DEVIATION REQUEST AND DECISION FORM

Project Name : SF221: Skyline at Lorson Ranch Filing 1

A deviation from the standards of or in Section **El Paso County Standard Drawing of the Engineering Criteria Manual (ECM) Detail SD 4-20**, is requested.

Exhibit showing Chemical
Grout Locations on Skyline at
Lorson Ranch Filing 1

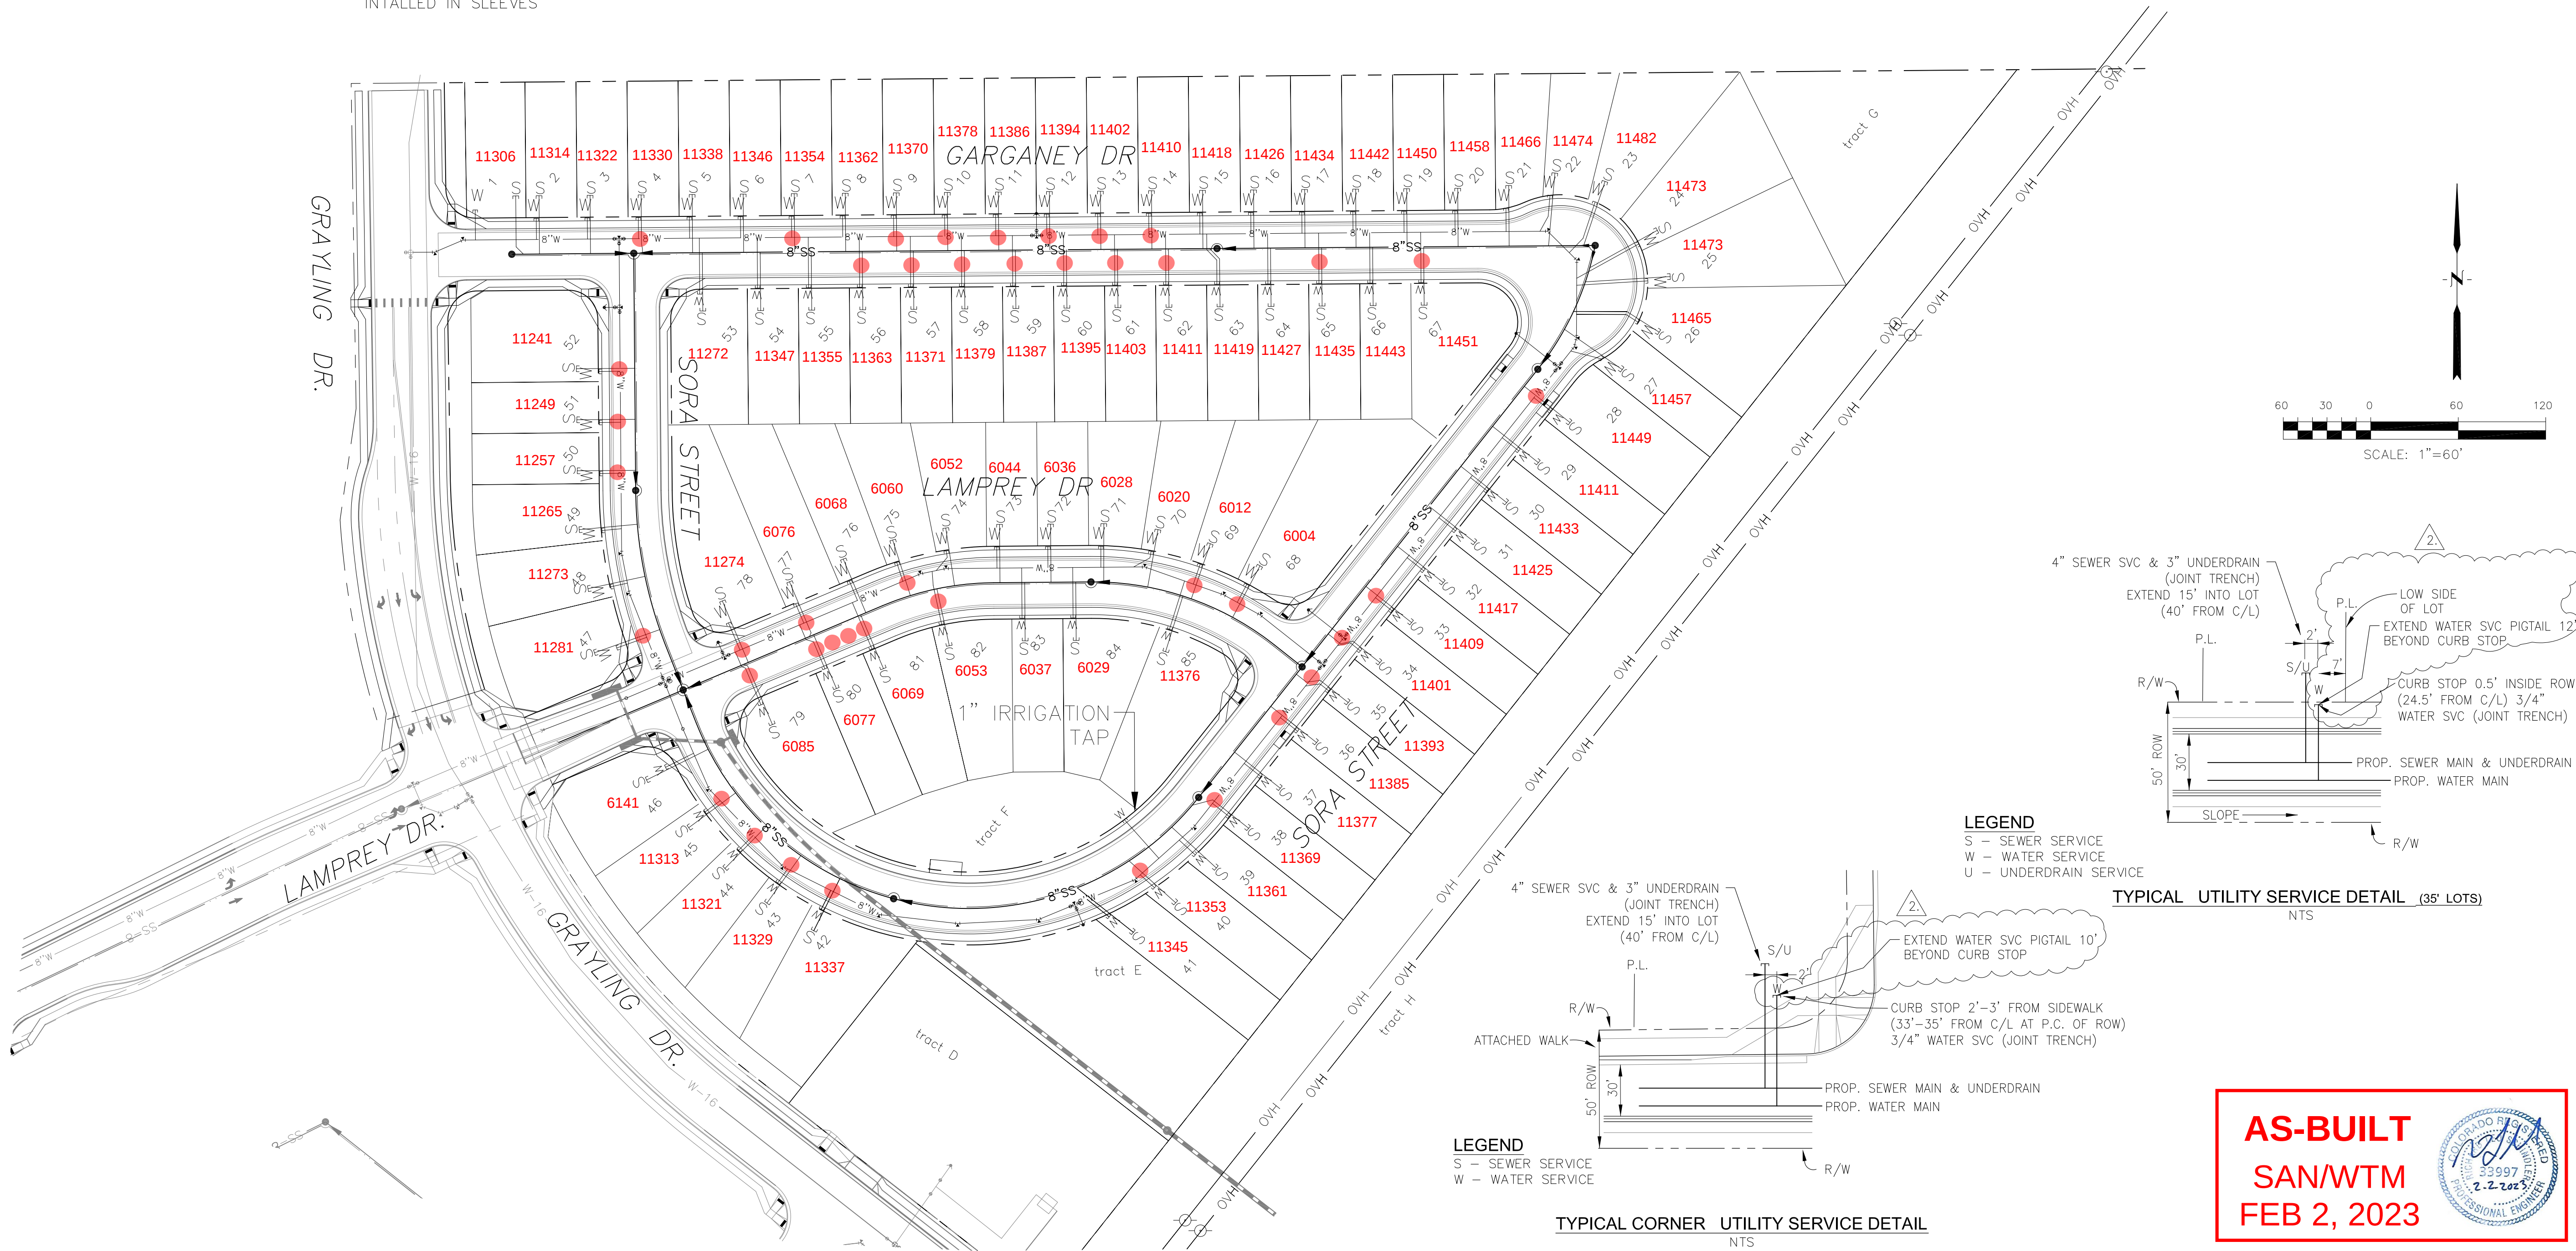
Deviation request for the use of the chemical grout to stabilize the soils within the roadway and utility trenches where settlement and distress were observed and to lift and relevel pavement, concrete flatwork, and stormwater catch basins. The deviation request is requested for Skyline at Lorson Ranch Filing 1 (File# SF221)

The chemical grout should initially be injected approximately 4 feet on center within the utility trenches through a 1/2" injection rod advanced to a depth no greater than 4 feet below land surface (bls) through 5/8" diameter drilled holes. After an initial stabilizing injection volume that will be determined on a case-by-case basis, the injection rod tip will be raised to approximately 1.5' to 2' bls or within 0' to 1' ft bls of the base of the cement-treated subgrade (CTS) to lift and relevel the concrete slabs or pavement. When being utilized to relevel installed stormwater vaults, concrete sidewalks, or concrete curbs, the material will be injected directly beneath the concrete. The elevations of the pavement/slabs should be monitored continuously during the chemical grouting

● Minimum 1/2" pavement deflection - area to be treated with chemical grout
